MWO 189-1

# **MODIFICATION WORK ORDER**

651S-1/1A
GENERAL PURPOSE
HF RECEIVERS
(KEEP-ALIVE)

**NOVEMBER 1974**

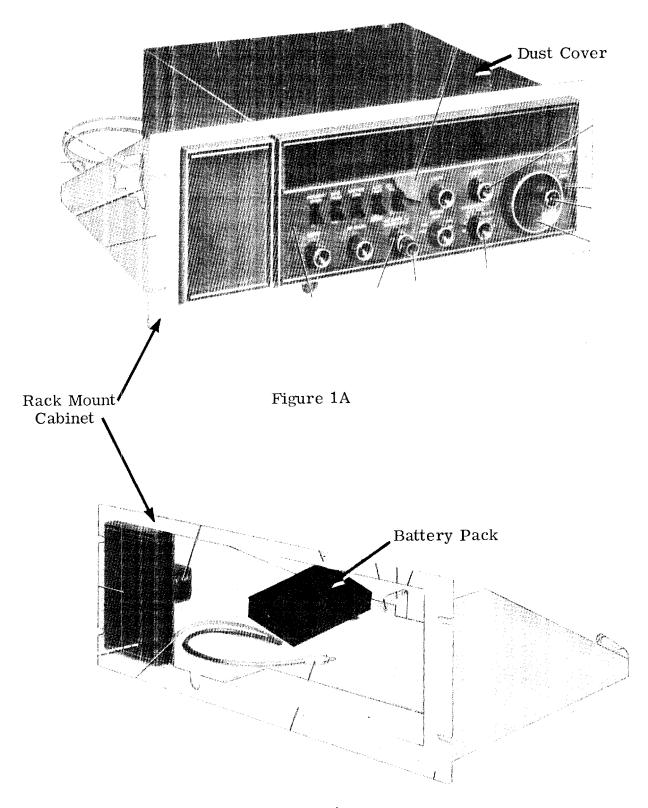
- 4.1 Remove the receiver from rack mount cabinet. See Figure 1A.
- 4.2 Remove the dust cover from the receiver.
- 4.3 Remove the hole plug in the hole designed for the remote control output plug J-63 on the rear of the receiver. See Figure 2 (Figure 39 Sheet 1 of 3 Parts List).

Figure 1B

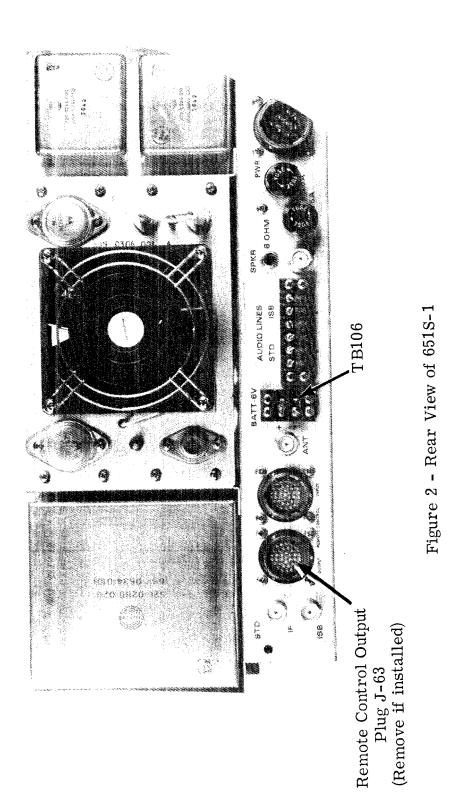
- 4.14 Re-install the receiver in the rack mount cabinet.
- 4.15 Remove the paper from the tape on the bottom of the battery pack chassis and press pack down firmly on rack mount cabinet next to the receiver as shown in Figure 1B.

Figure 3 - 651S-1 Receiver With Power Pack
Approved For Release 2001/07/16 : CIA-RDP8090833A000100030005-7

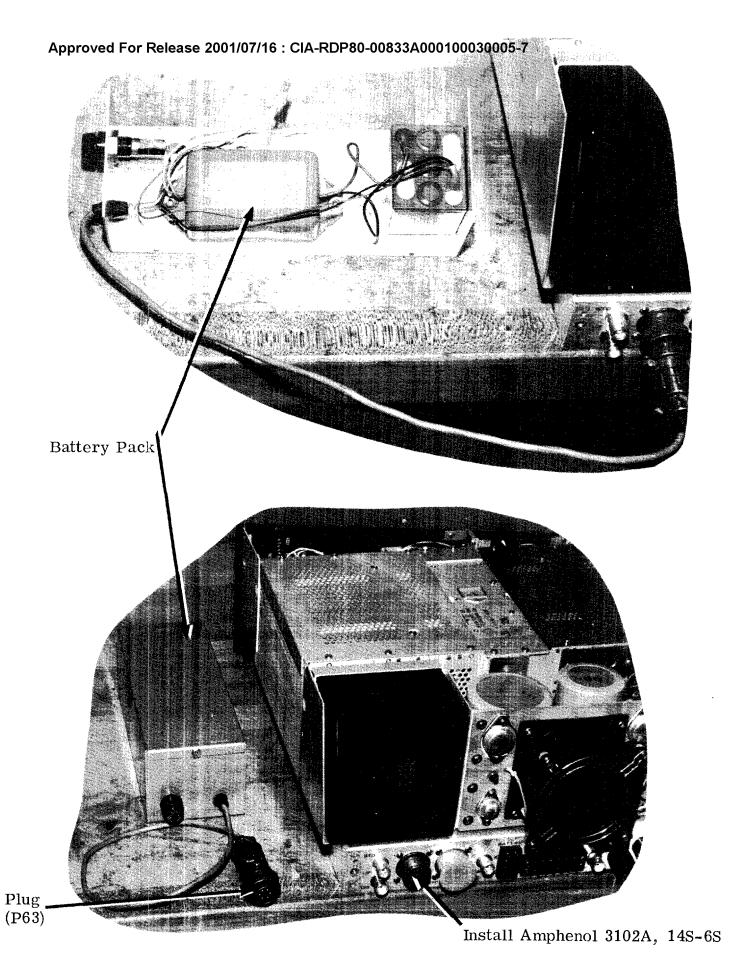
- 4.5 Install the pre-wired interface chassis mount socket (Amphenol 3102-A, 14S-6S) in the remote control output hole using the 4-40 nuts and bolts supplied. See Figure 3.

- NOTE: For purposes of standardizing, mount the socket with the key at the top. Solder the Red wire to the back of the positive terminal of TB106. Solder the black wire to the negative or ground terminal of TB106. See Fig. 3 & 8.

- 4.8 Remove the cover from battery pack and remove packing material.
- 4.9 Install the battery charger inside battery pack chassis using the holes and hardware provided. See Figure 3 for proper location.

- 4.10 Remove the paper from the tape in the bottom of the battery and press the battery down firmly inside battery pack chassis. See Figure 3 for proper location.

- 4.16 Connect the battery pack plug (P63) to the receiver. See Figure 3.
- 4.17 Pull the AC cord to check the KA circuit.

Figure 4 - 651S-1 Chassis

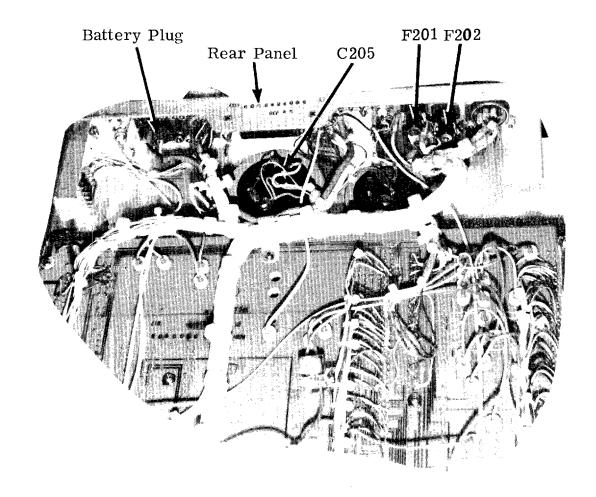
- 4.6 Solder the "White" and "Green" (110 Volt AC) wires to the rear most terminals of fuses F201 and F202. See Figure 4.
- 4.7 If the S109 Optical Tuning Switch is in an output state of "HI-LO" or "LO-HI" when the power failure occurs, with this modification, it will change the receiver frequency by as much as 400 Hz. If it is in a "HI-HI" or "LO-LO", no change will occur. To overcome this problem, the following steps must be performed.

Figure 5 - Rear View of Front Panel Assembly

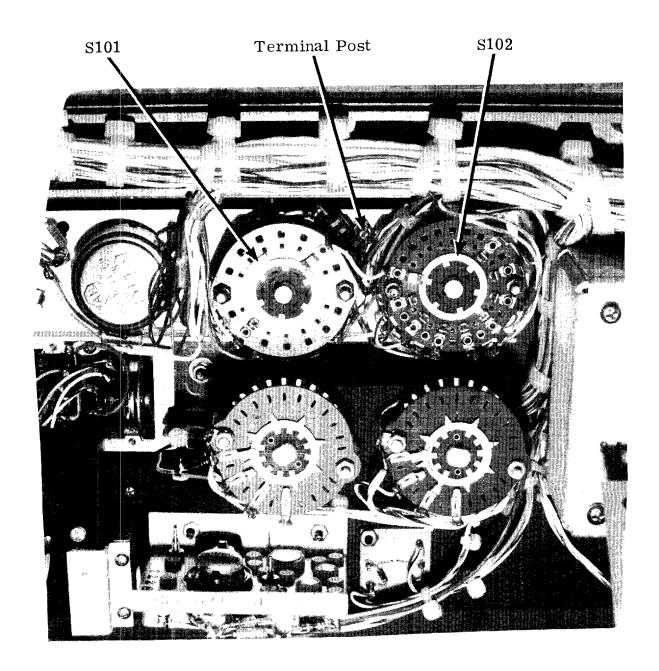
- 4.7.1 With front panel assembly removed and laying flat, locate the terminal post between the mode switch (S101) and bandwidth switch (S102) and disconnect the red wire from this post. See Figure 5.

Figure 8

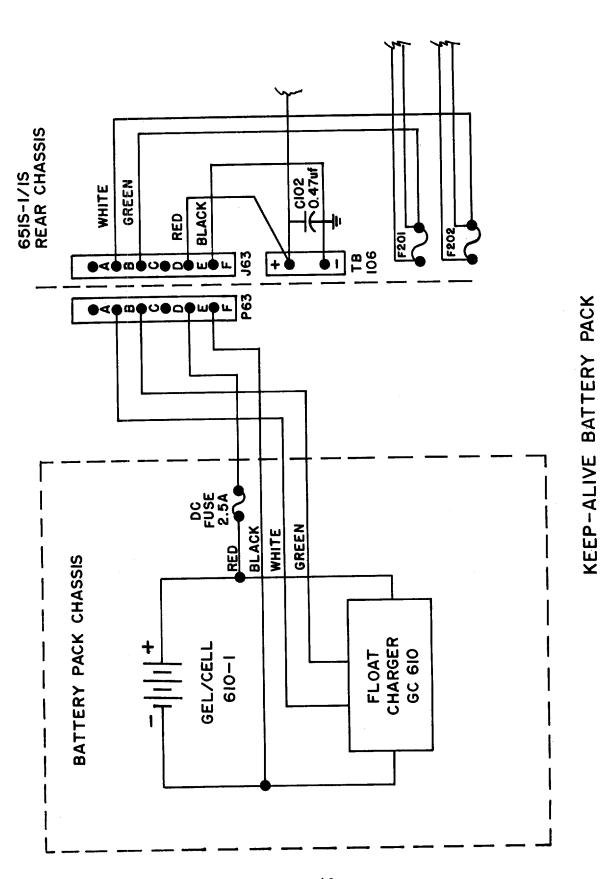
- 4.11 Make proper wiring connections to install battery charger and battery. See Figure 8 for wiring diagram.
- 4.12 Replace battery pack cover.
- 4.13 Re-assemble the front panel assembly and dust cover of the receiver.
